RE: Development within the Townlands of Cappagh, Clonburris Little Kishoge, Co. Dublin REG. REF. SDZ22A/0018

In response to a Further Information Request issued by SDCC after a Planning Application was submitted for the subject development, please find below and enclosed responses to items related to the Civil Engineering design. Note that where relevant, additional information may be provided elsewhere by other members of the design team.

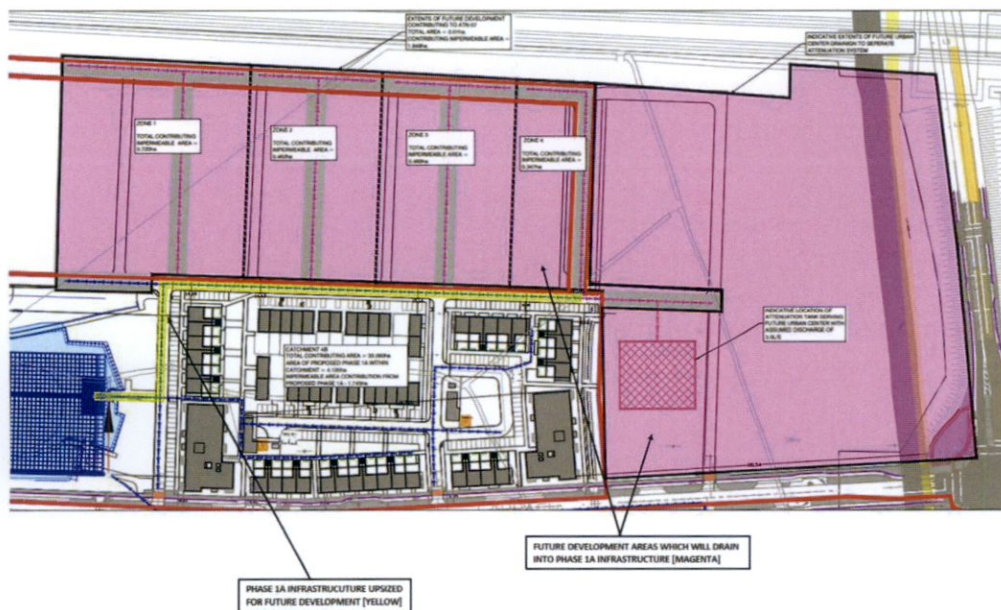
The applicant is requested submit a drawing with increased surface water attenuation and show the surface water layout to include connection to main surface water sewer in spine road. Clarify on drawing where proposed subsequent surface water attenuation systems will be.

As detailed in the "Item 10(a)", sufficient surface water attenuation storage has been provided within the attenuation pond as proposed on drawings CLB-1B-94-SW-DTM-DR-DBFL-CE-5005 and CLB-1B-94-SW-DTM-DR-DBFL-CE-1001.

The tie-in points to the downstream surface water network and regional attenuation ponds are as required by the greater Clonburris SDZ Surface Water Management Plan shown in the image below.
